MEMORANDUM

DATE: March 9, 2017

RE: **NMED Comments, Updated Closeout Plan and Financial Assurance Proposal, Deming Mill and Tailing Impoundment, GEO Southwest, Ltd., Luna County, New Mexico MMD Permit No. LU009RE**

DMS 1

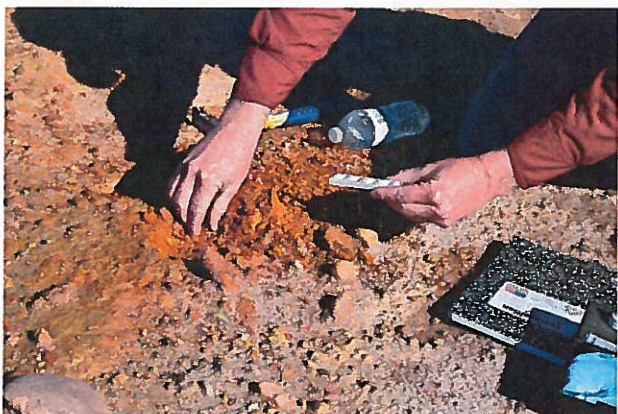
An eroded slope with rills exists adjacent to the FMI-Cyprus Tailings. A small area of tailings (DMS-1) was observed in the East-West swale on the slope. The tailings are orange in color and fine grained. The tailings exhibited acidic conditions with an approximate pH of 4.5 standard units as indicated with the colorimetric pH test kit. Erosional rills were observed at the toe of the slope with orange fine grained tailings exposed. The tailings in two locations (east and west end) exhibited acidic conditions with an approximate pH of 4.5 standard units. The center of this area exhibited a pH of 6.0 standard units. The pH of the black tailings in the area exposed at the toe of the slope exhibited a pH of 7.0 standard units.
